## Technical Bulletin

TB20230701

### Subject: Notice of VFD Compressor Without Copper Bridge(Jumper) Installation

#### **Hanbell VFD Compressor Series :**

#### **Installation position of copper bridges**

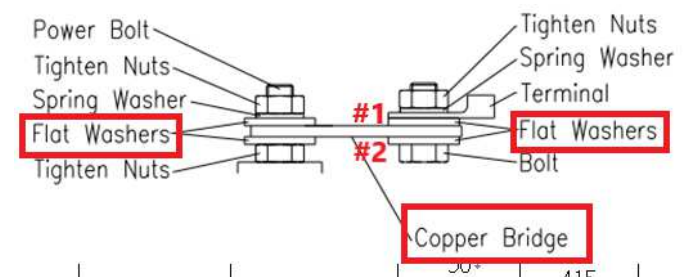
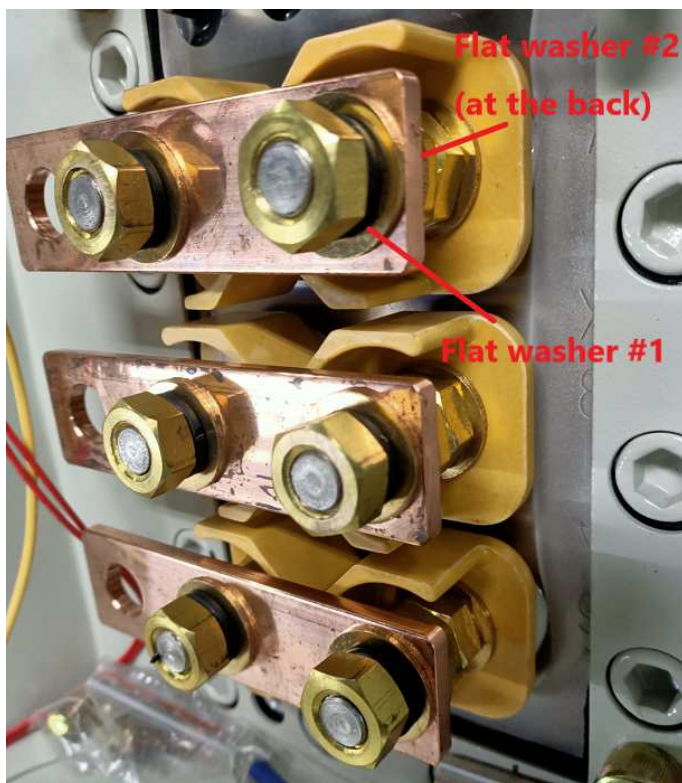
If the copper bridges are not properly tightened by technicians, it could indeed lead to serious consequences like motor failure or damage to the terminal plate, which is crucial for the compressor's operation.

By changing the practice and packing the copper bridges separately in the compressor accessory boxes, you are aiming to prevent improper installations and ensure that technicians install and secure the bridges correctly during setup. This seems like a good strategy for improving the reliability and safety of the compressor systems.

1. Valid from 1<sup>st</sup> August 2023, copper bridges as accessories (without installation).
2. It is based on issue dates of compressor orders from customers.

(Jumpers need to be assembled between flat washer #1 & flat washer #2)

Torque Value for power bolts	
Bolt size	Torque value (kgf.cm)
M8	200
M12	350
M16	500
